**COMMITTEE OF ADJUSTMENT
MINOR VARIANCE
STAFF REPORTS**

Owner(s): Franci-Lynn Mueller
Address: 544 Hurd Ave. Burlington
File No. **A-014/26**
Ward: 2

The applicant is proposing the construction of a roofed-over rear yard patio with a privacy screen.

roofed-over patio at rear

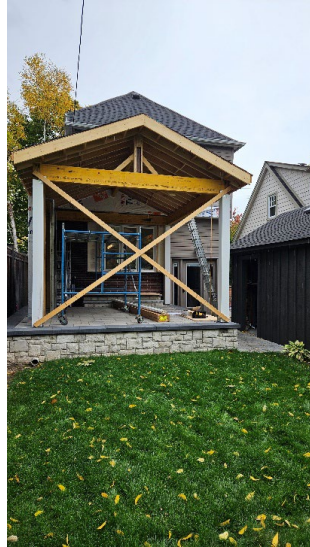
- Potential adverse effects related to noise or overlook are minimized by the existing wood fence, detached garage and privacy wall
 - As confirmed on the submitted drawings and documents, the exterior fireplace which forms part of the covered area, is vented directly up through the roof responding to previous concerns raised by Committee members

1 PROPOSED SITE PLAN
SP1.01 1:125

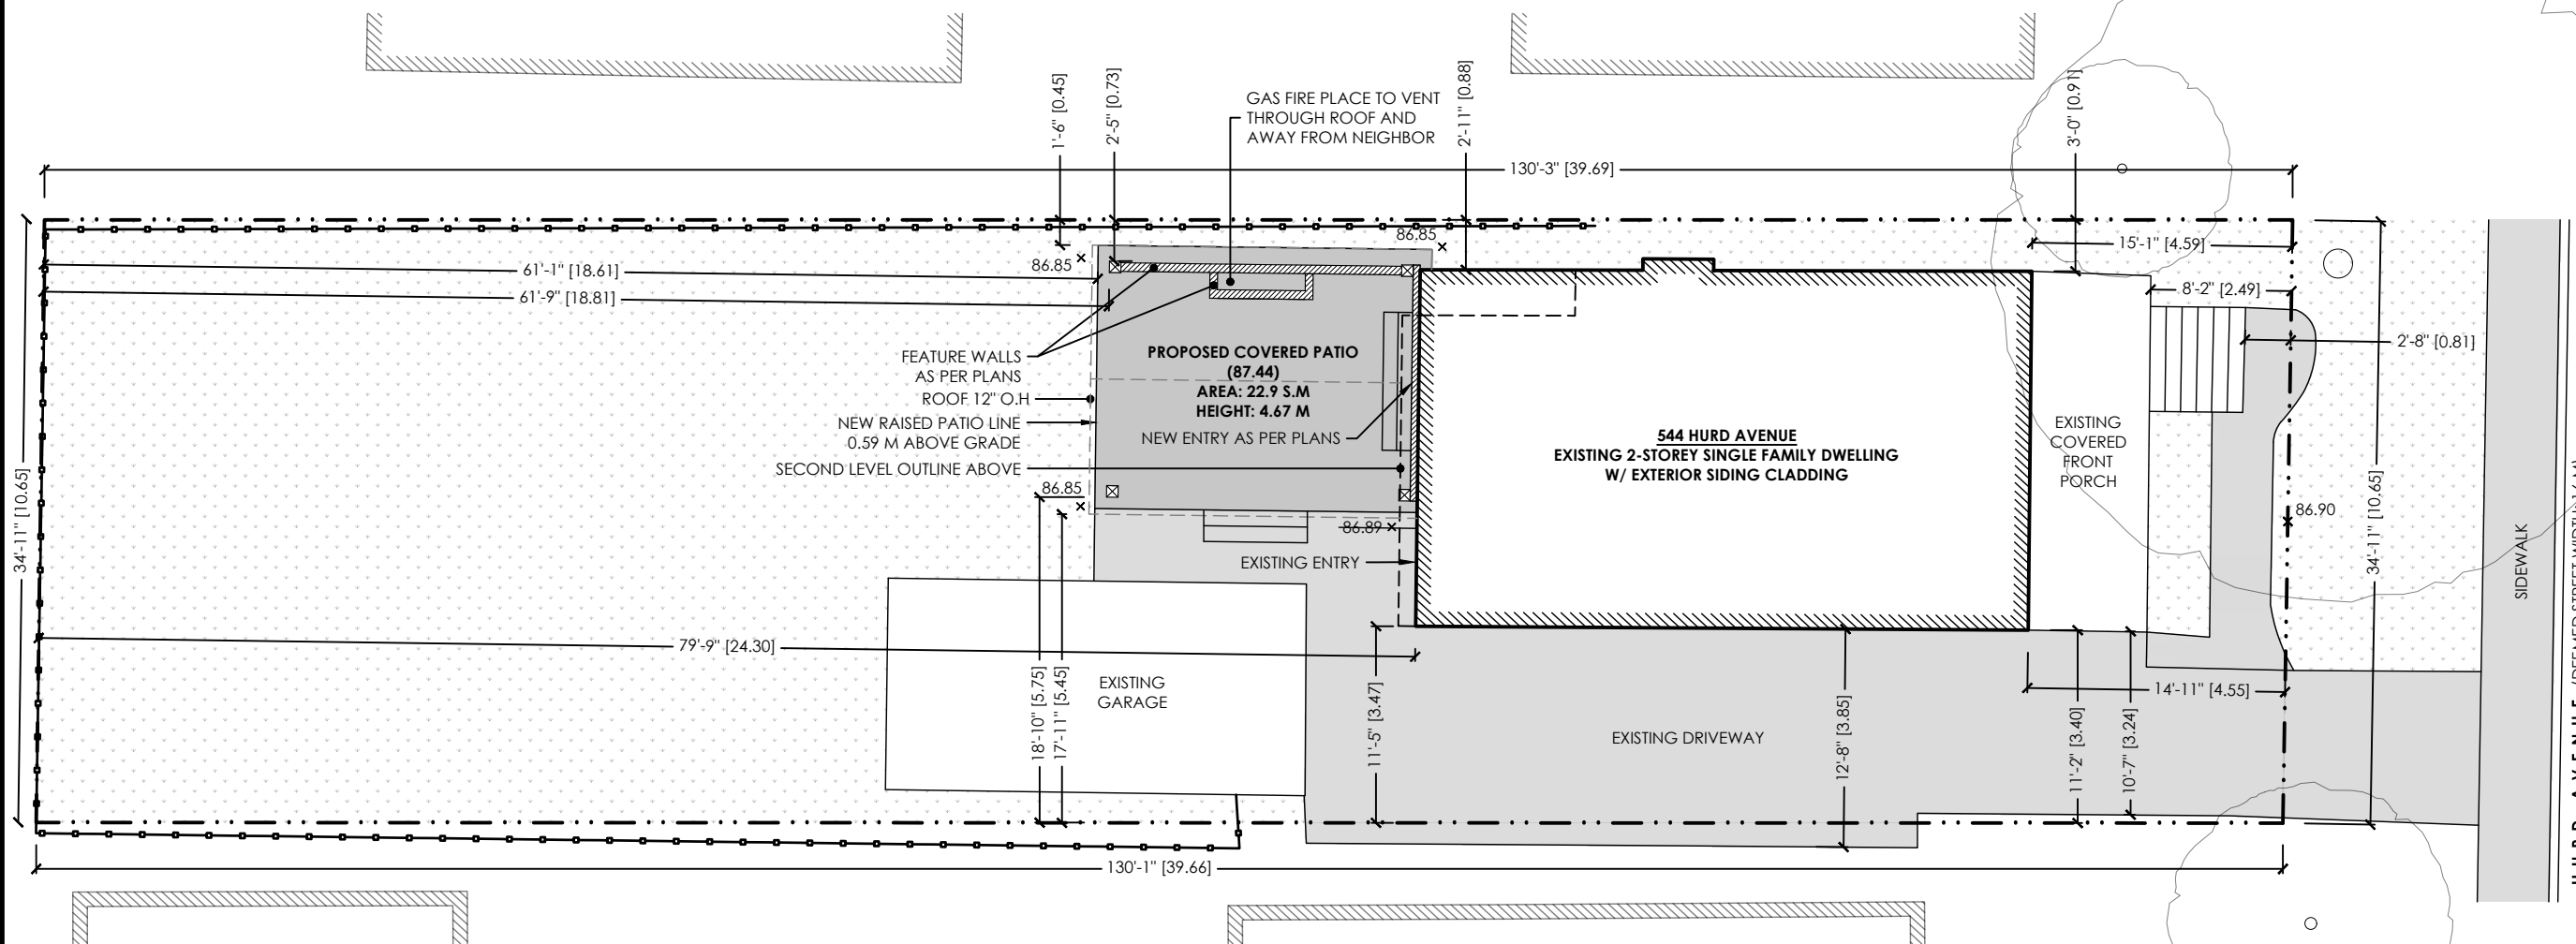
- As verified by Zoning staff, the technical wording of the variance remains unchanged as the setback requirement is measured to the roof overhang
- The outdoor fireplace associated with the covered patio structure has been revised to eliminate any additional projections into the side yard and is now flush with the wall of the privacy screen. This reduction, along with confirmation of the vertical

fireplace venting, is a positive change and addresses previous concerns related air quality and ease of access for any future maintenance

The revised design now provides a **clear side setback of 0.73 m to the post of the structure**, closely matching the existing house setback. The reason the proposed variance itself has not changed is that the measurement is taken to the **roof overhang of the structure**, not the post – that is, the area that is free to move. While the variance remains 0.4 m, there is now a **clear and accessible space of 0.73 m**, which is the key difference in this proposal. Additionally, the fireplace will be **vented through the roof**, ensuring there is no impact on the neighbouring property, which was another concern raised by the Committee.
